TN15 RESPONSE TO FURTHER LHA COMMENT - EMPLOYMENT

VERSION	DATE	PROJECT NUMBER AND NAME	CREATED BY	REVIEWED BY
2.0	11.03.2026	23161 – Buntingford	JD	MG

- 1.1.1. Ridge, as acquirers of Jubb Consulting Engineers, has been retained by Hallam Land Management to provide transport and highways advice in relation to a proposed employment development on land to the west of Buntingford and within the district of East Hertfordshire.

- 1.1.2. A planning application has been submitted and validated on the 11th of July 2024 (planning application reference 3/24/1255/OUT), for an 'Outline planning application for development of employment land (flexible use B2, B8, E(c) and E(g)), informal open space, associated works and infrastructure including a new access from A507, with all matters reserved except for access'. The latest associated land use components plan for this is set out in **Appendix A** of this Technical Note (TN).

Table 2.1 – Extract showing increased setback on northbound exit relating to the A10 / Baldock Roundabout junction

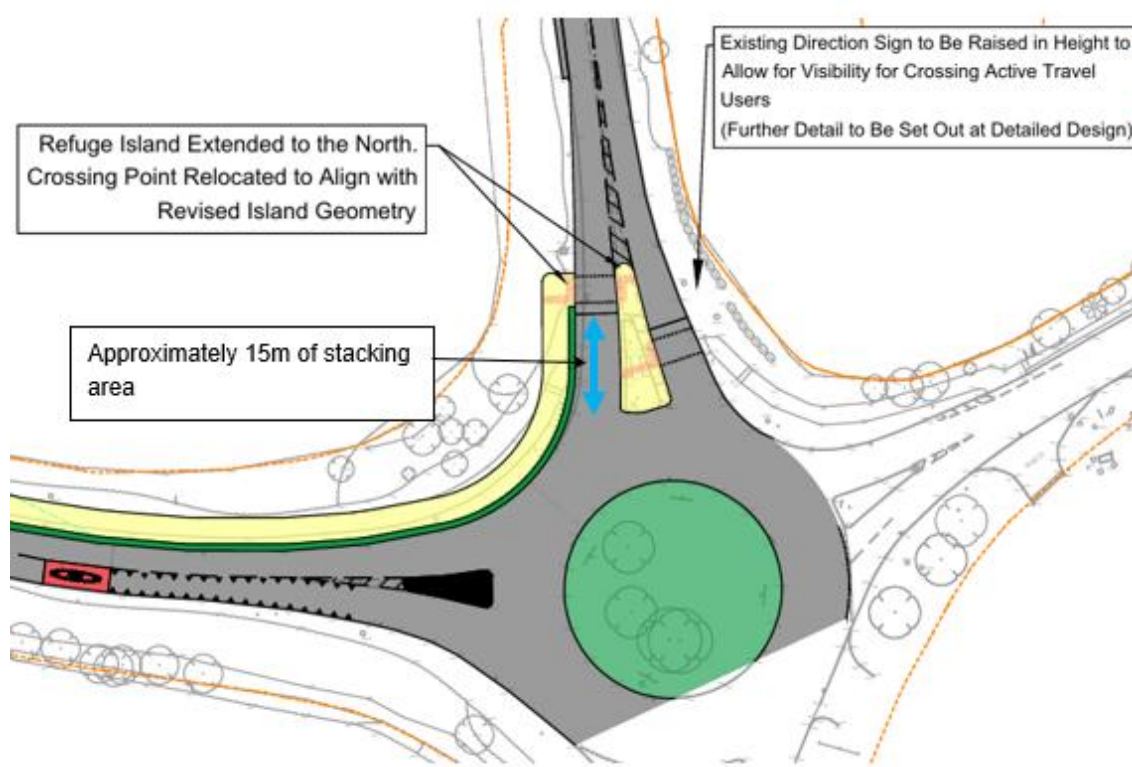
LHA Comment 1

"Toucan crossing on the A10

A signal controlled crossing positioned very close to the A10 roundabout entries and exits remains a fundamental concern. On the exit side in particular, a red phase would risk queues forming back onto the circulatory carriageway, with the associated blockage and collision risks. On the entry side, the proximity also interacts with the "constant green" behaviour that has been raised before. These points would need very careful consideration in the Road Safety Audit (RSA) and through supporting queue modelling."

- 2.1.10. Notwithstanding this, in consideration of the comment raised by the LHA relating to exiting movements it is proposed that the exit crossing be set back further (by approximately 5m) to a point approximately 15m from the roundabout exit. This setback is similar to the positioning of the exit crossing shown on the aforementioned eastern arm of the Cattlemarket roundabout in Newark. The revised access drawing showing this change is included as **Appendix C** of this TN, which also includes appropriate swept path analysis for large vehicles using the amended northbound exit. An extract has also been included below as **Figure 2.1** to indicate the amended exit queuing area.

- 2.1.11. To note the extension of the island has been achieved through widening of the exit lane and no amendments have been made to the vehicle entry that would impact junction modelling. Furthermore, the additional setback also still provides an effective balance in relation to provision of vehicle stacking space whilst maintaining a crossing position in accordance with the active travel user desire line.

Figure 2.2 – Proposed layout at Land to the North-west of Buntingford

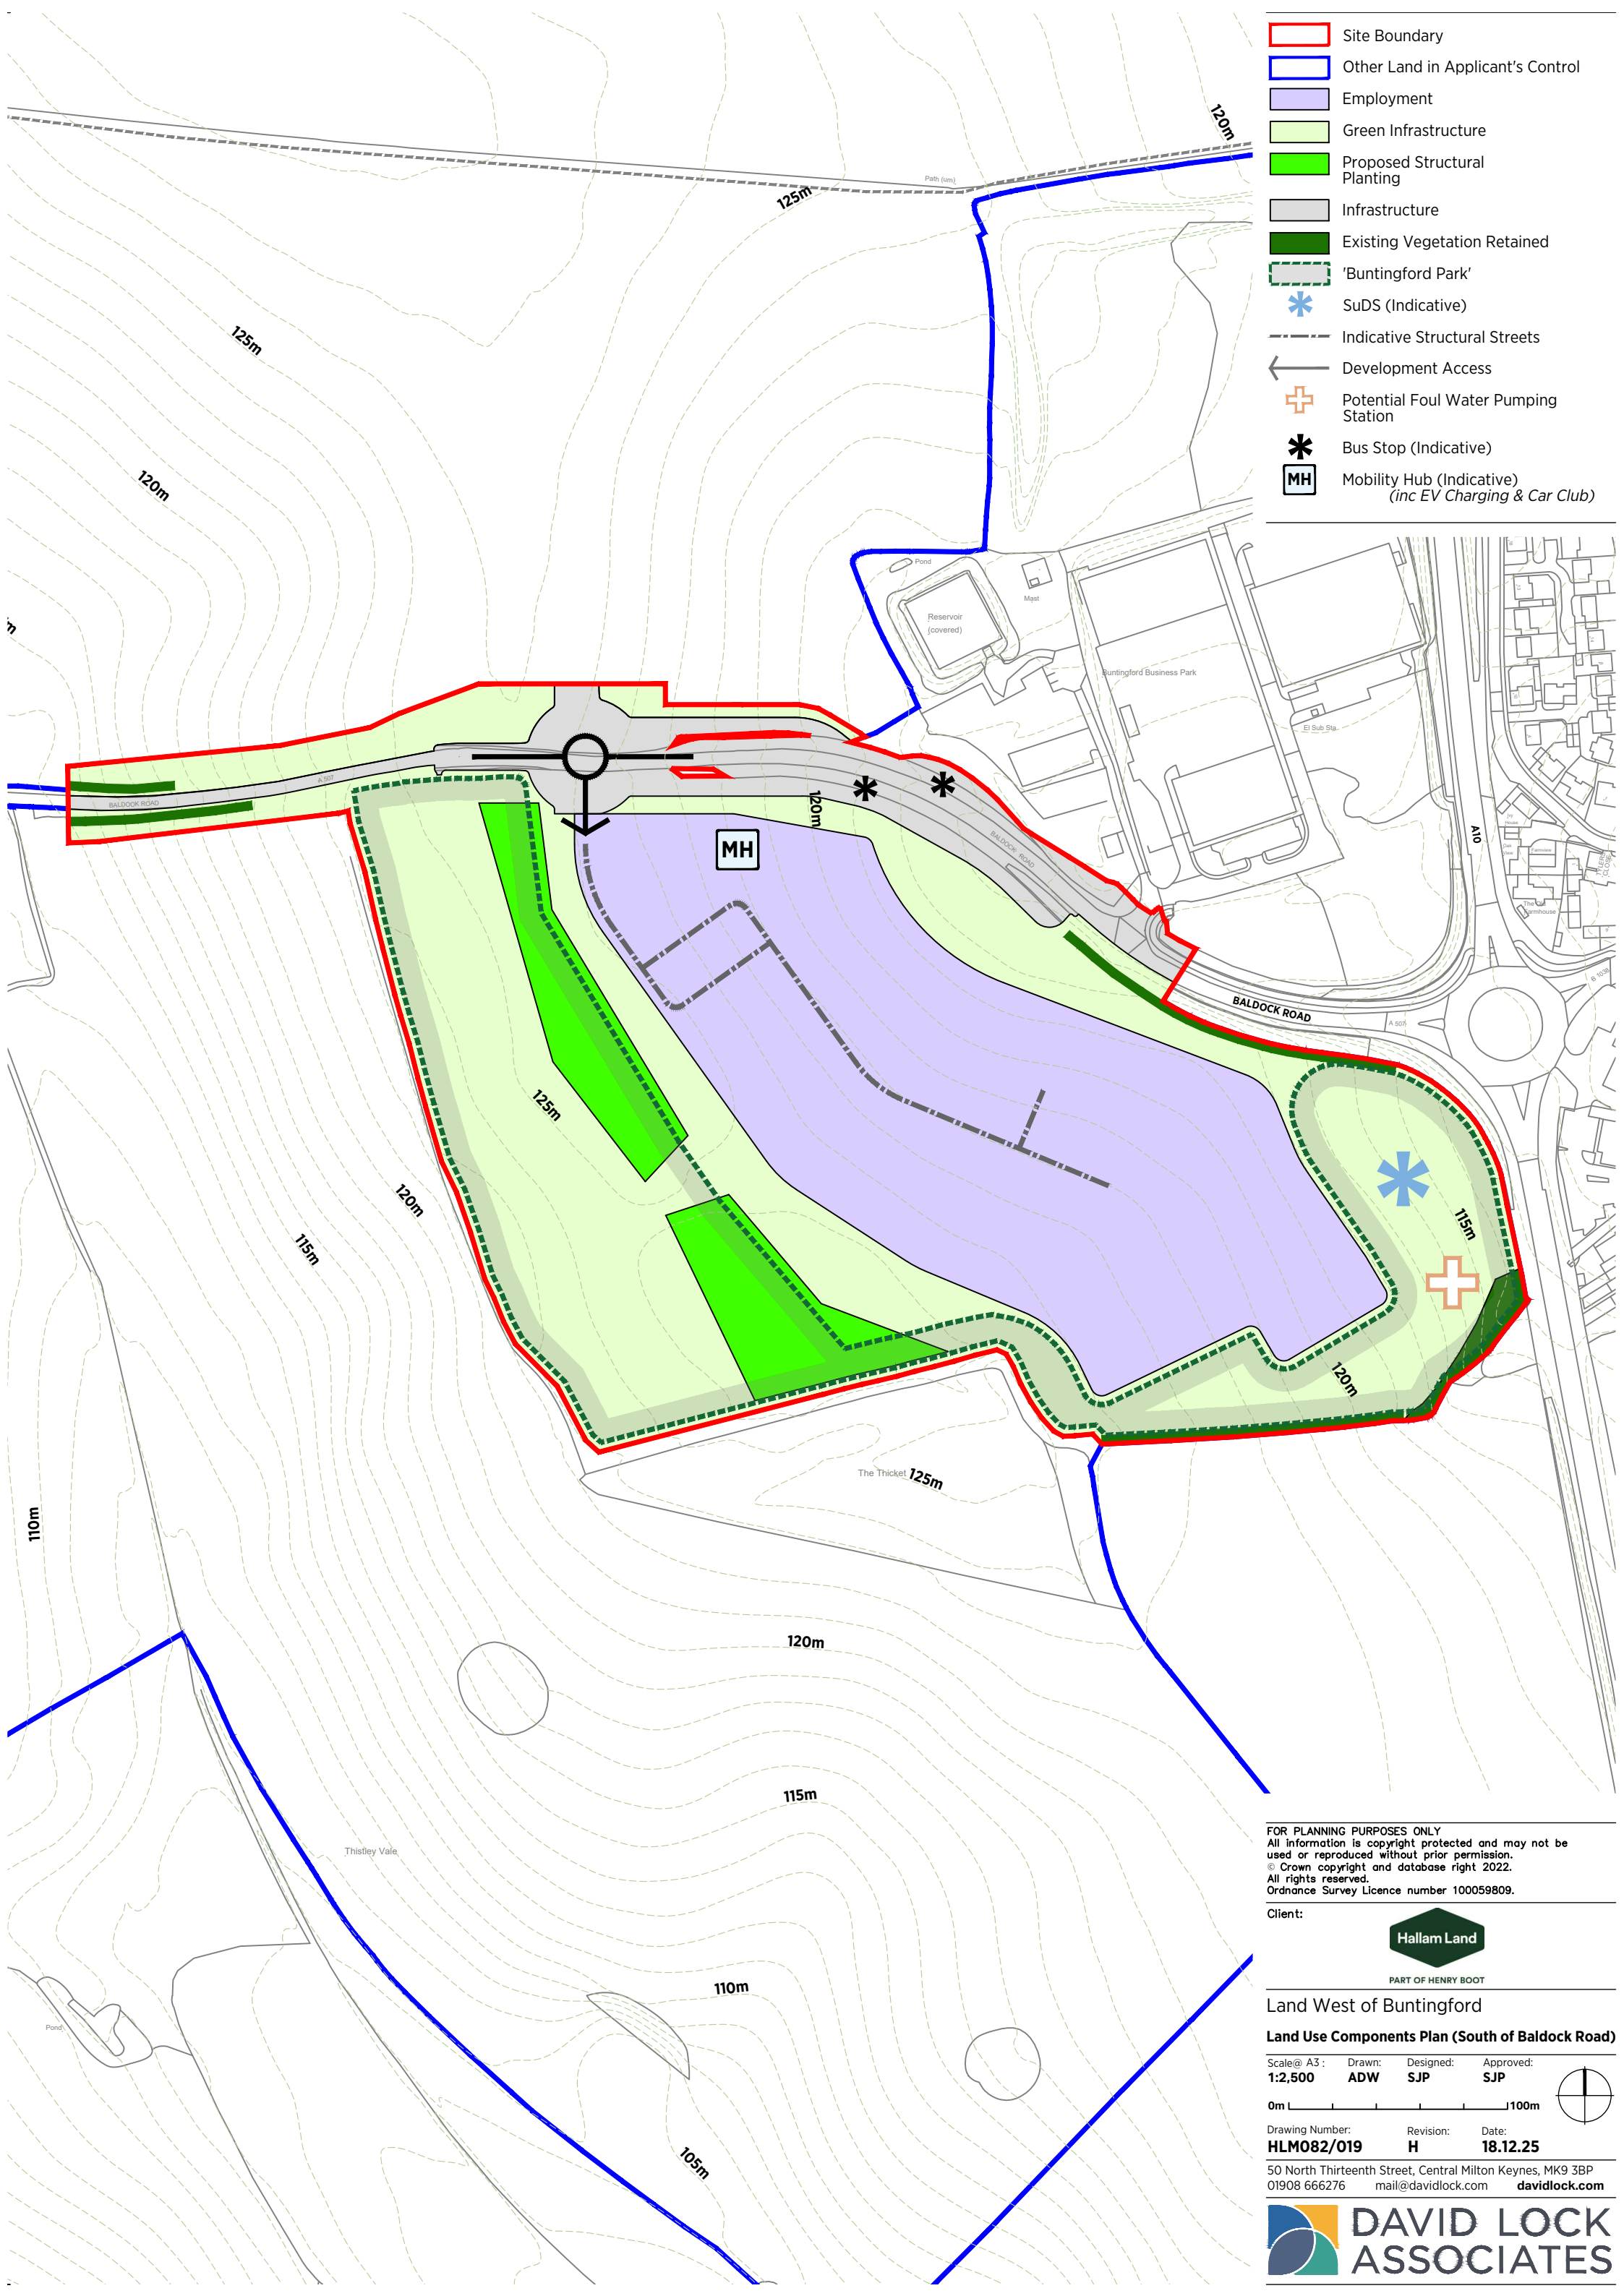
“Proposed extension of the 40mph limit

The proposal to move the 40mph limit roughly 1.1km north of Neale Drive, together with a crossing warning sign, also raises issues. There is currently and no proposed active frontage or meaningful change in roadside environment along this section of the A10, so it isn't clear how the reduced limit would be interpreted consistently by all road users or how it would remain logically justified.

We have seen on other routes that long, isolated 40mph sections in areas with limited frontage can lead to overtaking issues, greater speed variability, and in some cases a general disregard for subsequent speed limits further along a journey. When the environment does not reinforce the posted limit, predictable behaviour becomes harder to achieve, which has implications for every road user. This is presented in HCC Highways adopted Speed Management Strategy (Nov 2020).

- 2.1.12. To note the recent introduction of the Neal Drive connection has already provided a feature for drivers to consider on approach to Buntingford and to make necessary driving decisions to account for potential movement that could occur both out of the junction and into the junction. Thus, the extension of the speed limit to just north of this point is both appropriate and logical in that it further marks the new edge of Buntingford.

- 2.1.13. It is also noted that outline planning consent exists for residential development in this area (i.e. the Land to the North-west of Buntingford proposals) that would introduce housing on the A10 either side of the Neal Drive junction. A reserved matters application has also been submitted for these proposals (Planning Reference 3/25/1921/REM). The proposed layout of this site (alongside the original parameter plan), as set out in the latest Design and Access Statement Addendum dated December 2025, is extracted and set out in **Figure 2.2** below. This layout clearly shows the establishment of built form up to the A10.
